Access Compliance Report

Public Rights-of-Way

(Island Curb Cuts)

Intersection ID: 53534	Main Street: N_JOSH_BIRMINGHAM_PY	Cross Street: WILKINSON_BV	Location: SE
ADA ID: 99EBF344E0C4	Curb Cut Type: IslandRefuge3	Initial Pass/Fail: Fail	Overall Compliance: No
Codes/Mitigation Info/Possible Solution		Field Measurements/Component Compliance

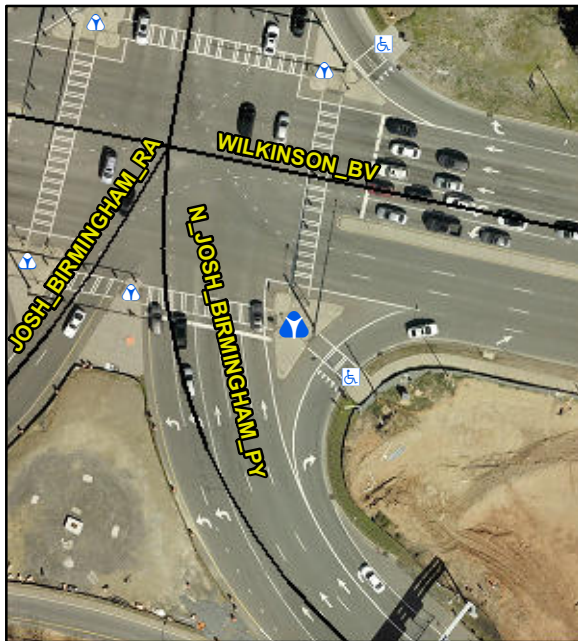
Remove & Replace Entire Refuge.
